Dam Safety
May 2019

**ALBERTA TRANSPORTATION SPRINGBANK OFF-STREAM RESERVOIR PROJECT
RESPONSE TO NRCB AND AEP SUPPLEMENTAL INFORMATION REQUEST 1, JULY 28, 2018**

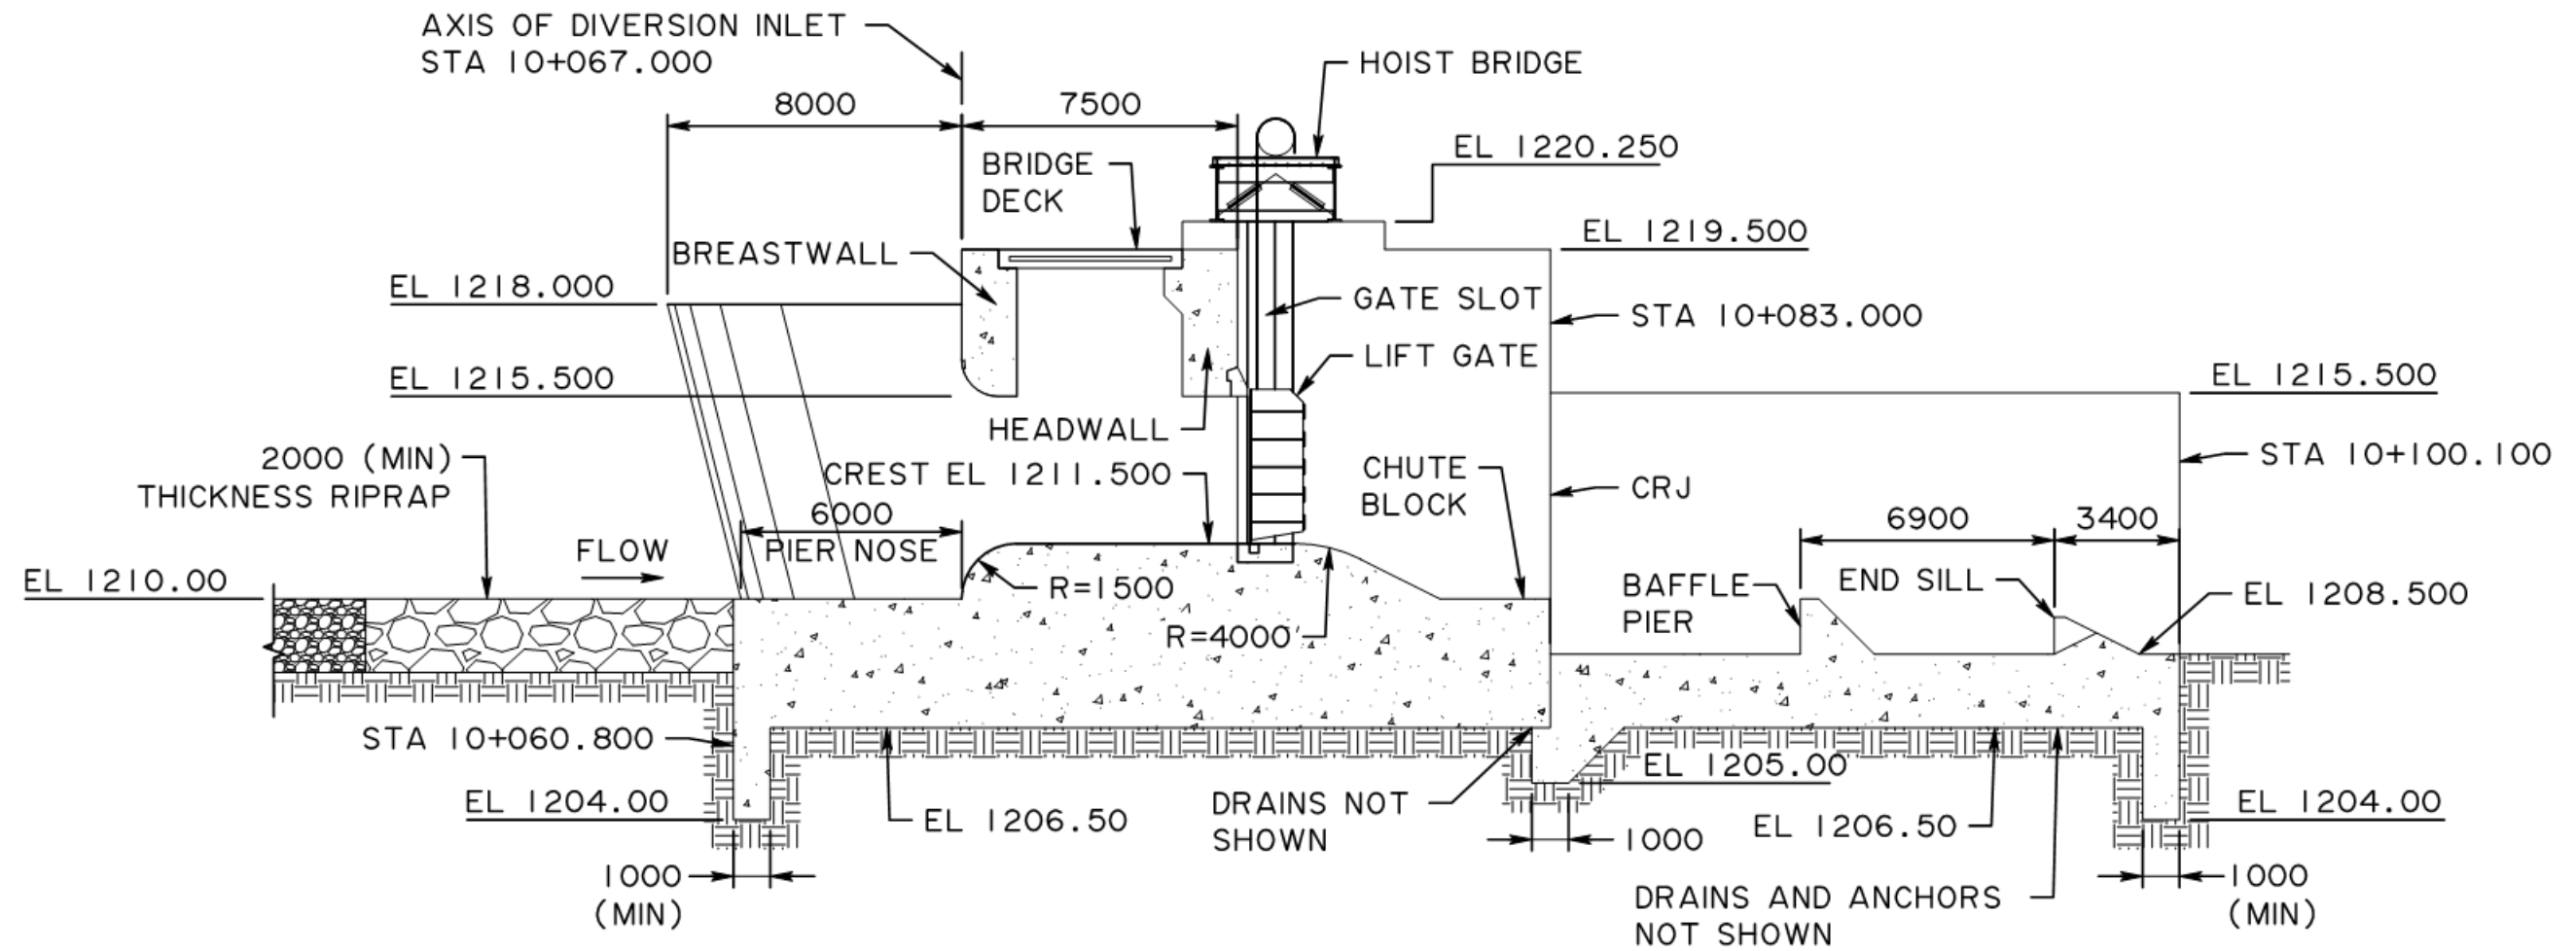
- a. Provide the design diversion capacity and water level, main structure components, and principal dimensions and elevations.
- b. Describe measures to prevent seepage/piping and drainage measures.
- c. Describe erosion protection measures (e.g. at entrance and downstream of the stilling basin).
- d. Describe construction requirements including temporary works (e.g. site clearing and grubbing, dewatering systems, foundation preparation, etc.).

- a. The diversion inlet is a concrete gate structure located on the left bank of Elbow River at the entrance to the diversion channel. The primary elements of the diversion inlet are:
 - left abutment, retaining walls, and embankment transitions
 - two 20 m wide gate-bays with a center pier-divider and fixed crest El. 1,211.5 m
 - two 20 m wide by 4 m tall vertical lift-gates with wire-drum hoist and hoist support spanning the 20 m bay width
 - access bridge—comprising bridge deck, breastwall, and headwall—that provides access to gate equipment, vehicle access across the diversion channel entrance, and it is a debris and overtopping barrier during extreme flood events
 - stilling basin with chute blocks and end sills to provide energy dissipation and minimize channel erosion
 - right abutment, retaining walls, and embankment transitions

A cross section through the centerline of the diversion inlet is presented in Figure IR456-1. The design maximum discharge capacity (600 m³/s) is calculated to occur at headwater El. 1,215.8 m.

Figure IR457-1 Service Spillway Gate Rating Curve (24 m Wide Bay)

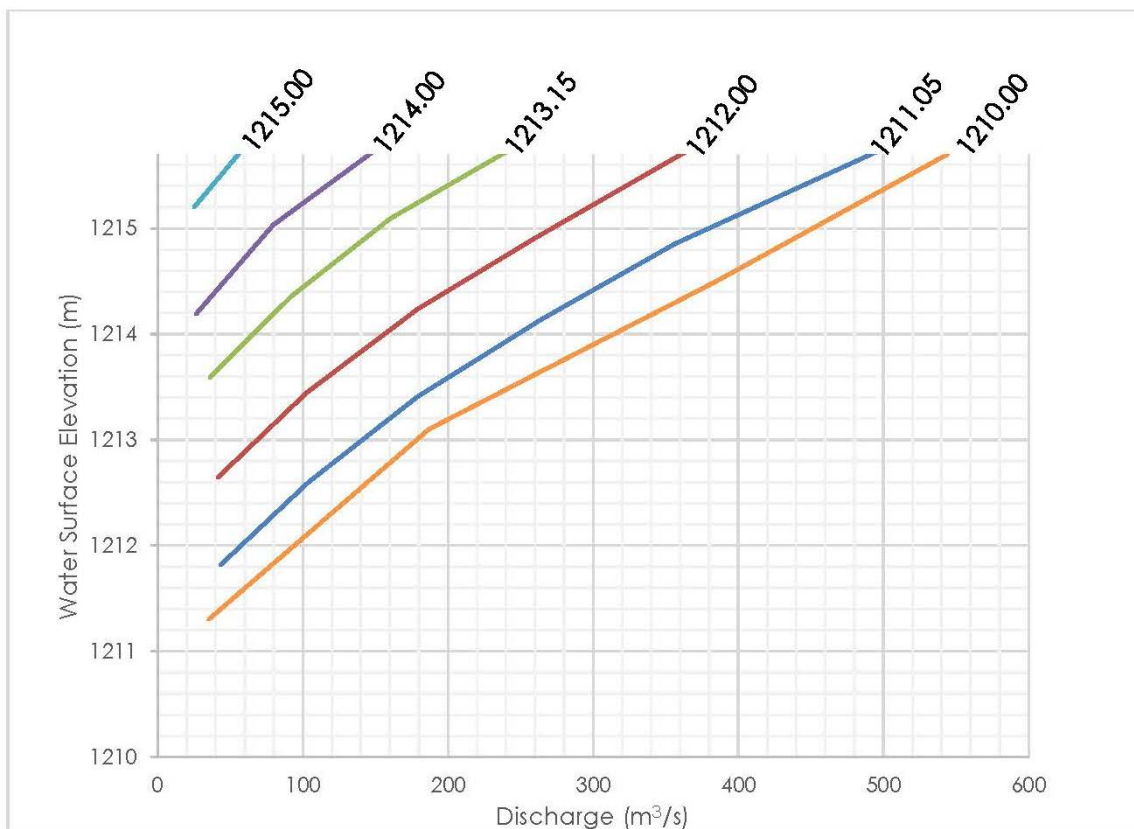
- a. Provide the design discharge capacity (e.g. gates down) and design water levels (e.g. gates down and gates in operation).
- b. Describe the main structure components and provide the principal dimensions and elevations.
- c. Describe measures to prevent seepage/piping and drainage measures.
- d. Explain the reasons for backfilling the stilling basin with native substrate. Does this have to be maintained?

- a. A series of rating curves was developed for the service spillway for six gate positions, based on results of the physical model and numerical models. Figure IR457-1 provides the relationship between headwater elevation and discharge for the six corresponding gate positions for a single 24 m bay.

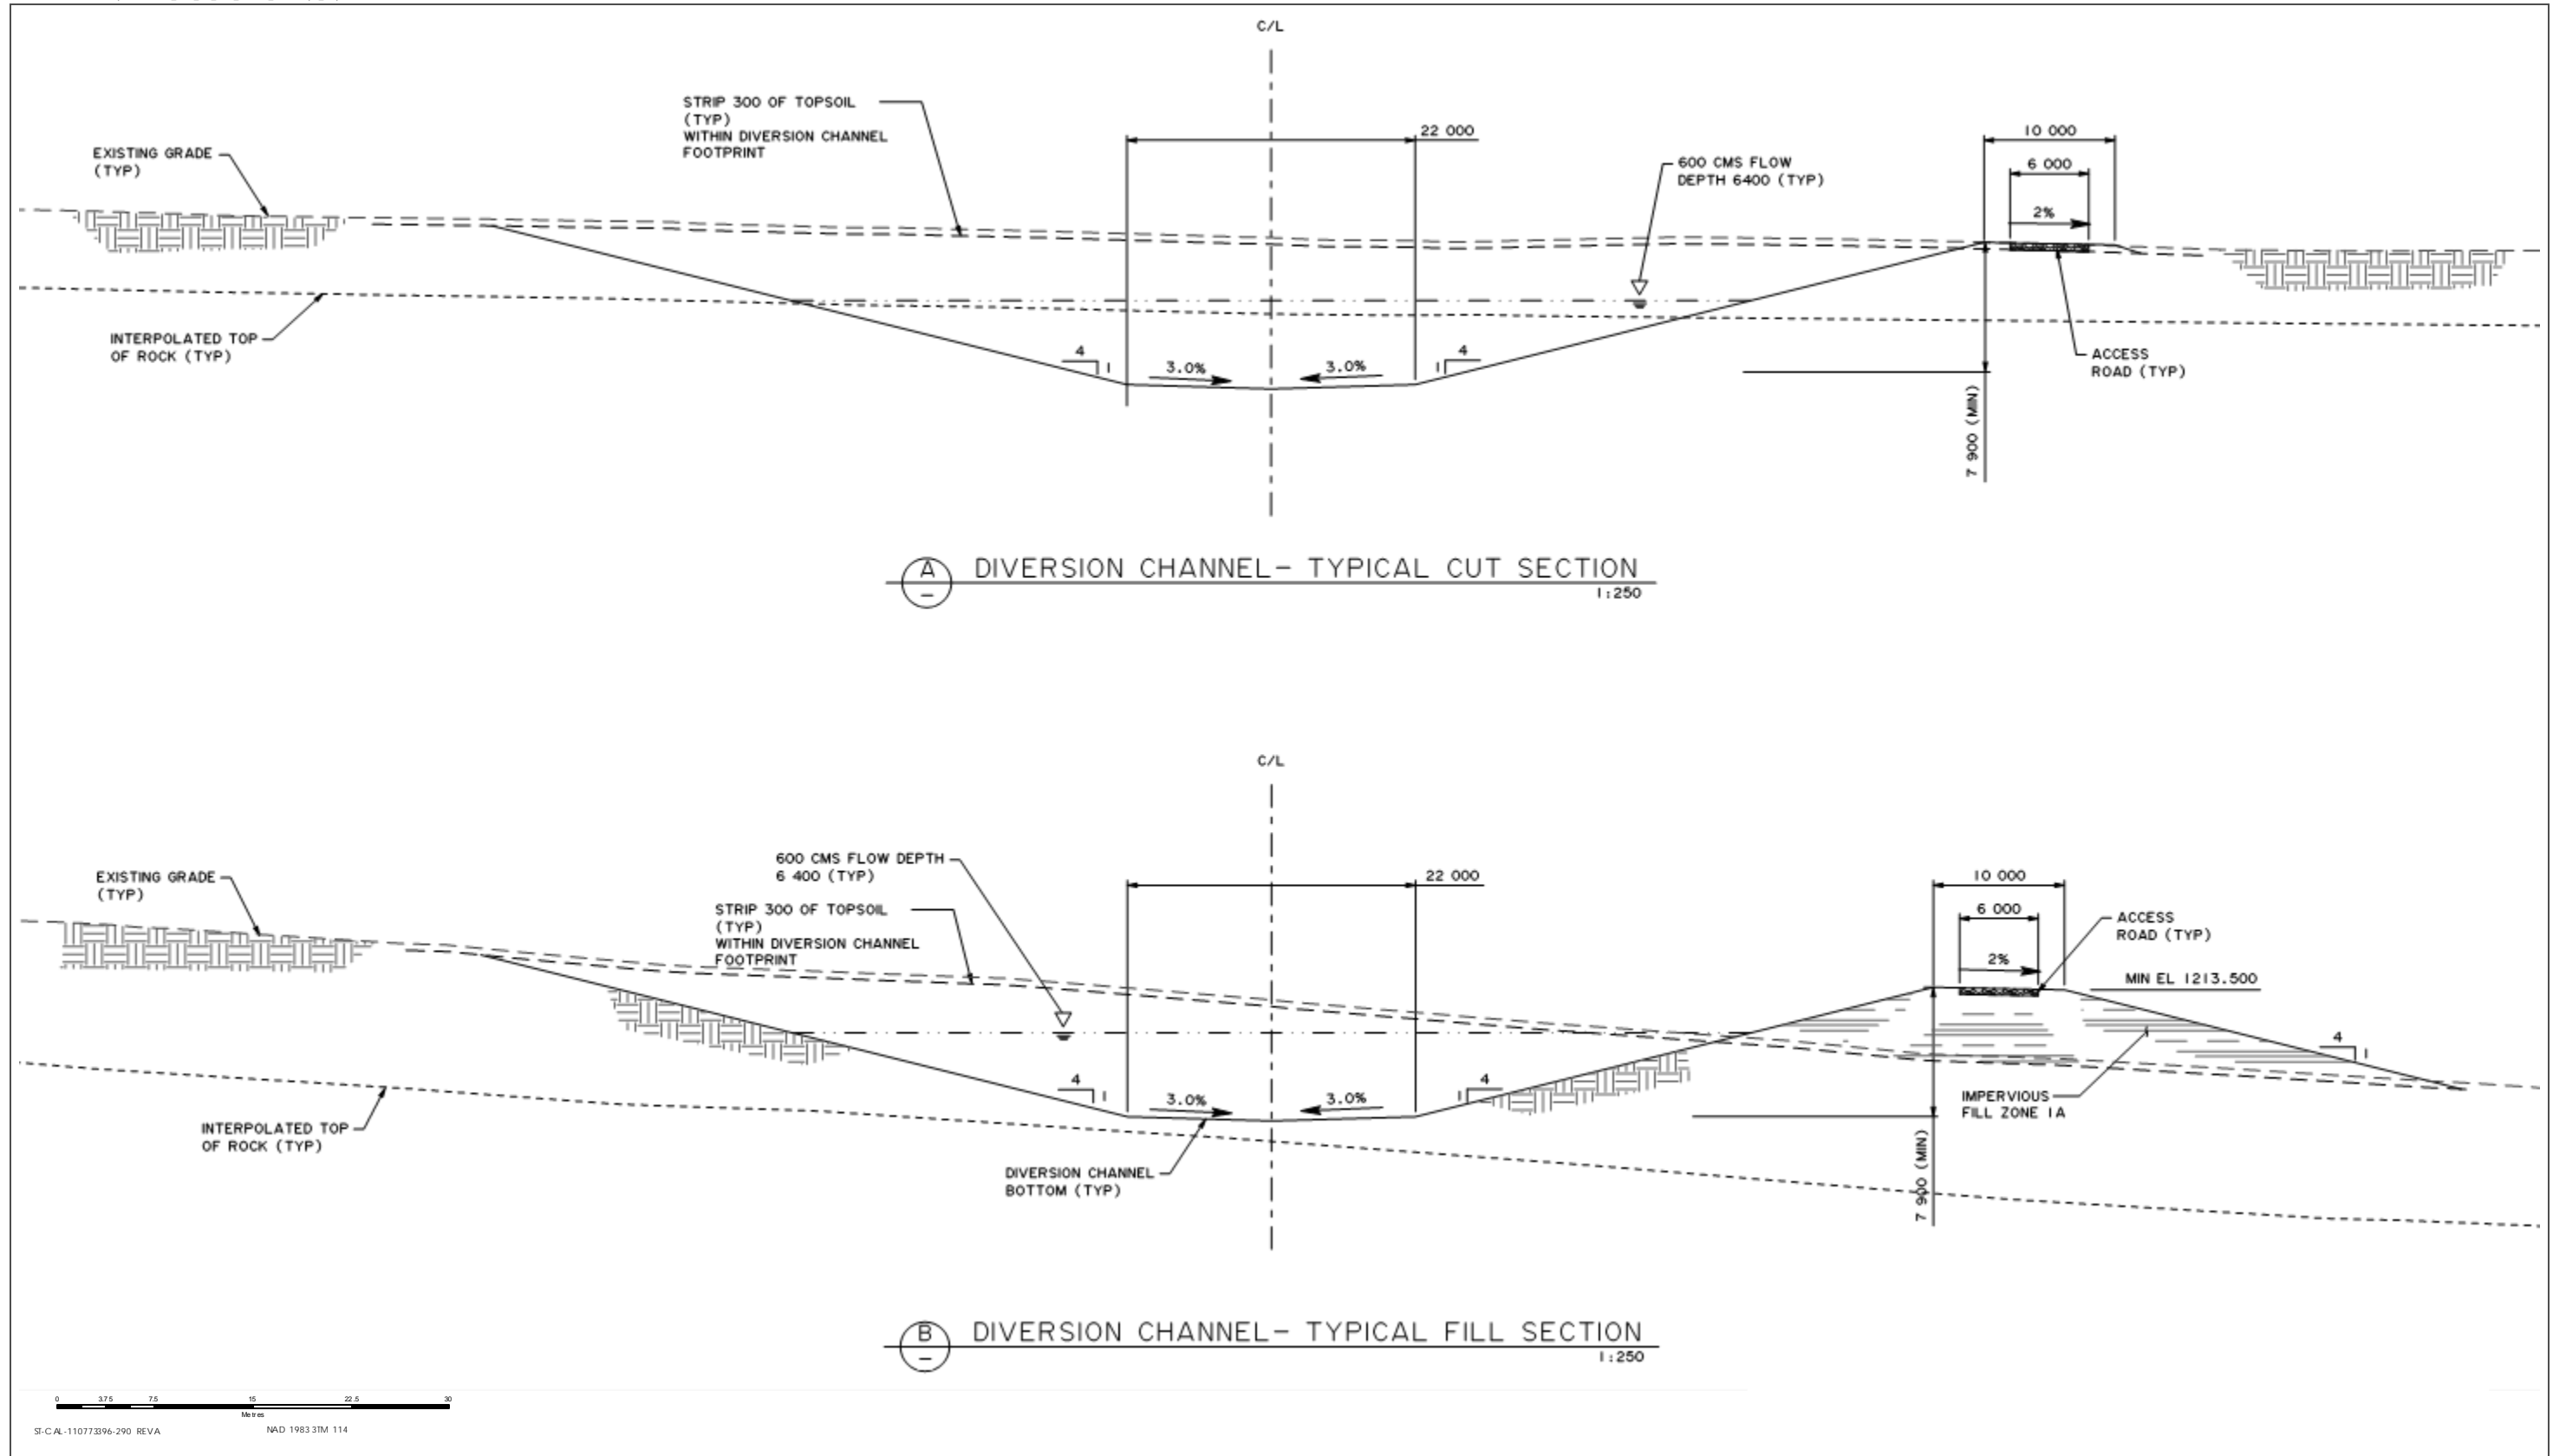
- e. Provide typical design cross sections in cut and fill.
- f. Describe the excavation and stockpiling requirements.
- g. For the two bridges across the diversion channel, explain if large debris that finds its way past the diversion inlet can collect at the bridge piers and block the channel.

- e. Figure IR463-1 provides typical diversion channel sections in cut and fill sections. These are representative for the channel through rock and/or soil.

Figure IR465-1 Reservoir Drawdown from Full Service Level

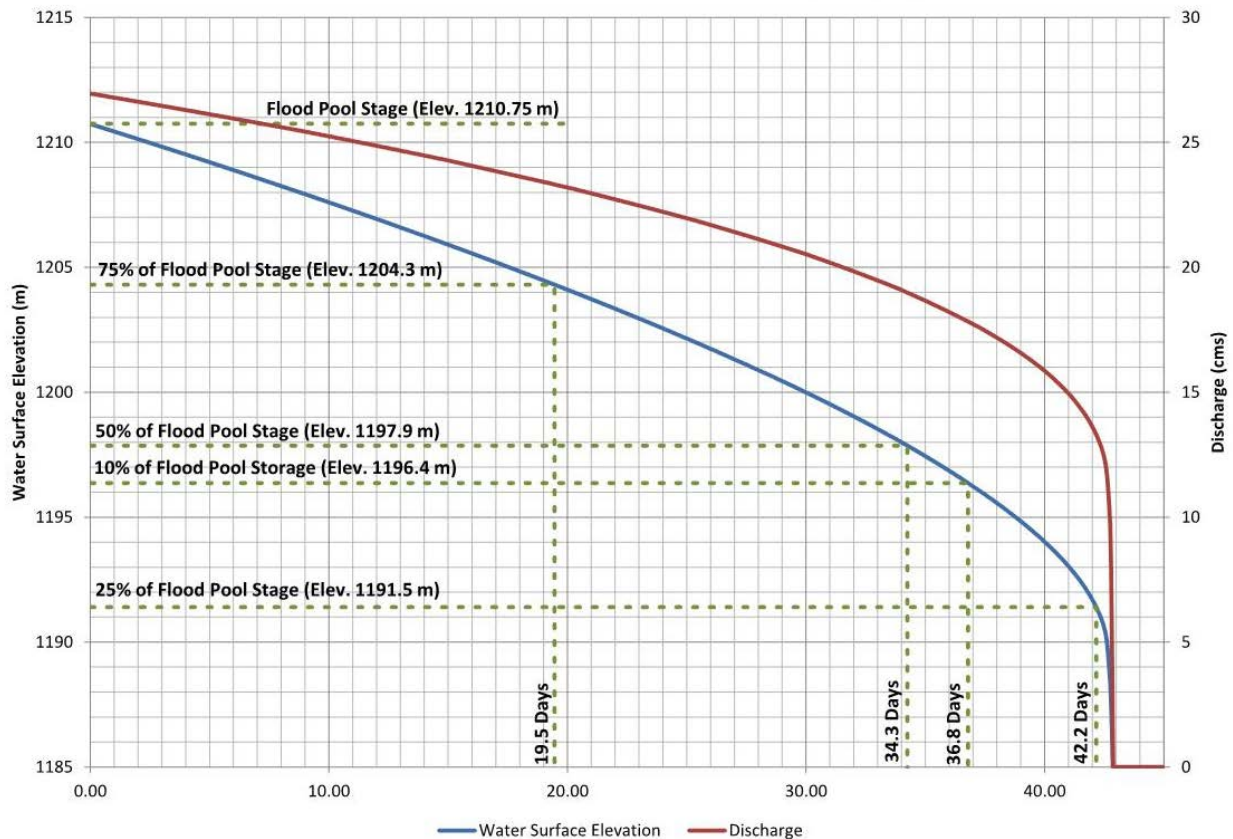
- a. Why are the residence and release times for the larger 2013 flood less than that for the 1:100 year flood?
- b. Explain the reservoir evacuation criteria (e.g. levels and times) in case of an emergency at the dam, that are being used.
- c. Provide the reservoir's operating rules with actual filling and releasing times/rates/levels corresponding to various flood events and conditions.

Figure IR465-1 presents the drawdown rates for the off-stream reservoir with the prescribed flood pool stage identified. The blue line on the figure represents the reservoir stage over time. At each of the defined criteria stages, the elevation and drawdown time are noted. As an example, the 75% stage (El. 1,204.3 m) is achieved in 19.5 days, which meets the minimum criteria of 20 to 30 days.

Figure IR468-1 Seepage Gradients for Sta. 22+925

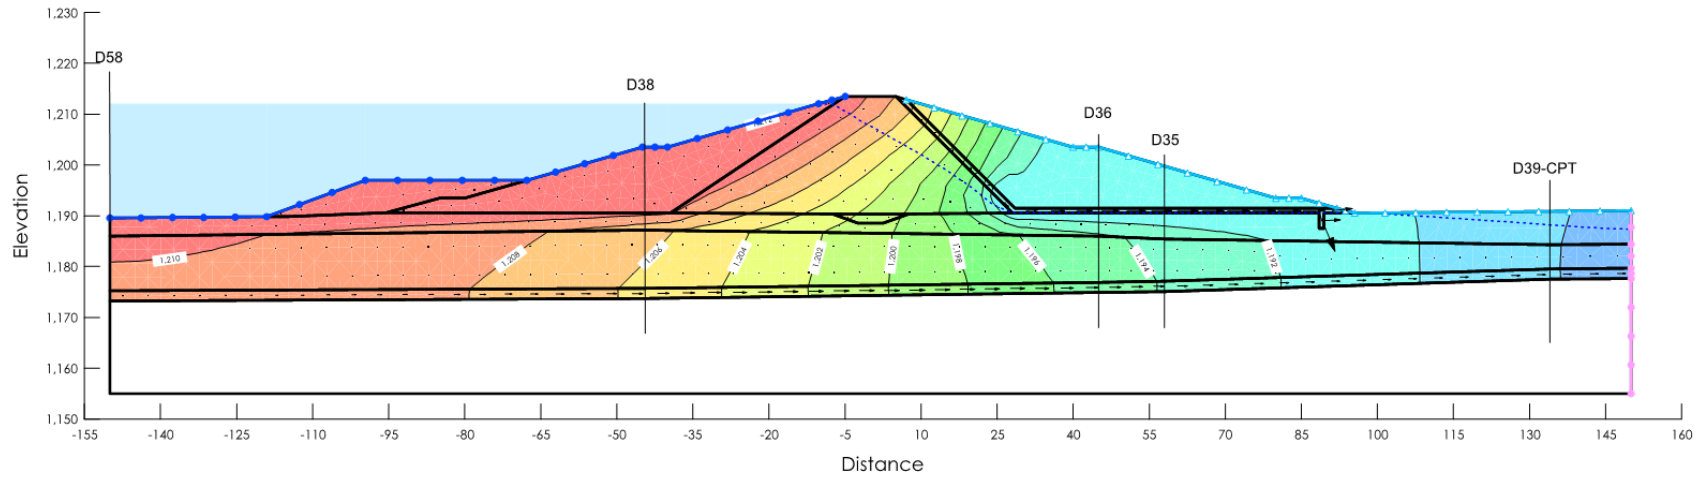
- a. Provide a discussion on foundation materials underlying the dam and saddle dyke including what seepage control requirements are necessary and how these requirements might vary across the bottom of the valley and abutment areas. Describe or show the typical dam cross sections in the vicinity of the low level outlet near the No Name creek channel.
- b. Explain why a nominal cutoff trench would be sufficient for part of the dam when a deep cutoff trench is required for the floodplain berm on the Elbow River and drains are proposed near the low level outlet structure.

Results of the seepage analysis for the typical cross section underlain by GL/GT is shown in Figure IR468-1.

Figure IR475-1 Preliminary Rating Curve for Low Level Outlet Works

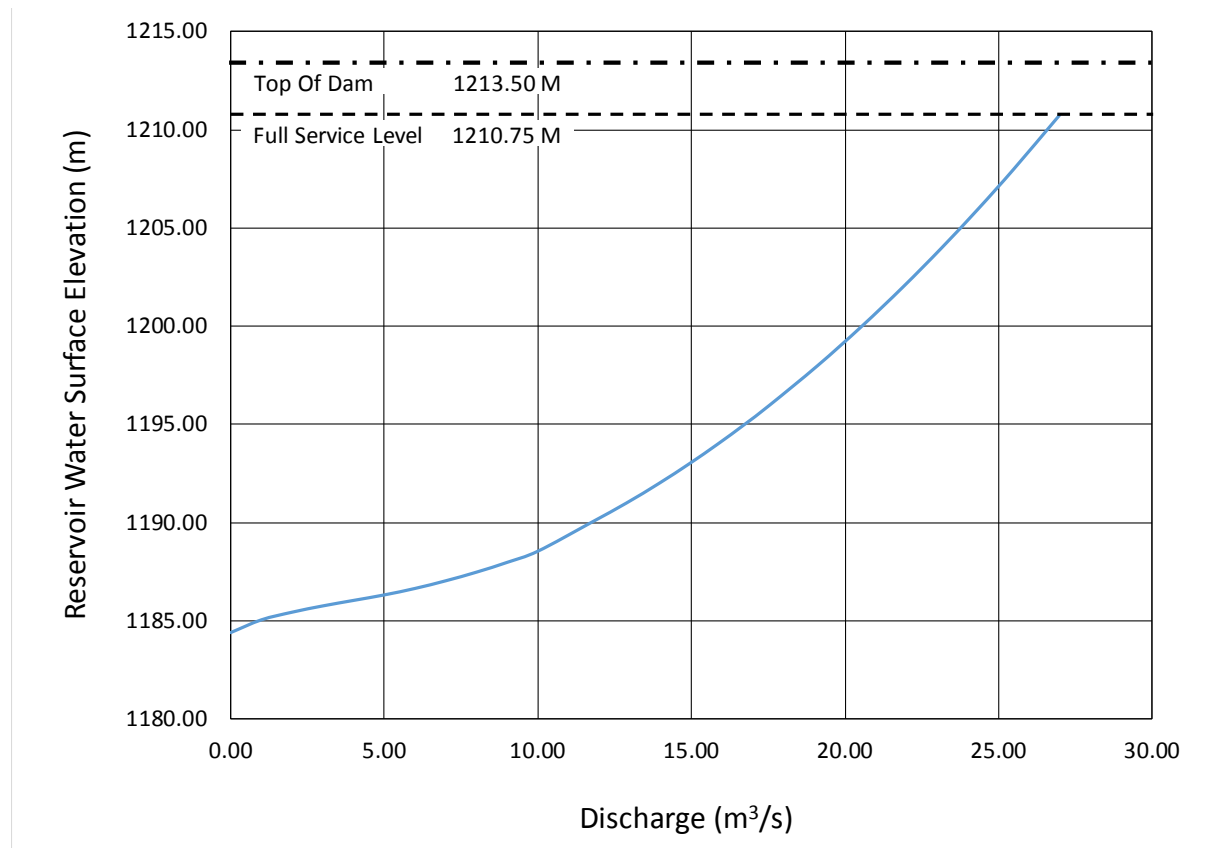
Alberta Transportation states that *The low-level outlet structure (Figure 3-10) consists of an approach channel, discharge gate, gatehouse, discharge conduit and outlet channel. The gate is operated locally by the gatehouse. Figure 3-10 is labeled Low Level Outlet but only shows the basin at the downstream toe. The photo in this figure is a picture of another project with a similar basin but with twin conduits that are round instead of the actual conduit shape for this project.*

- a. The preliminary rating curve for the low-level outlet works (LLOW) is provided in Figure IR475-1.
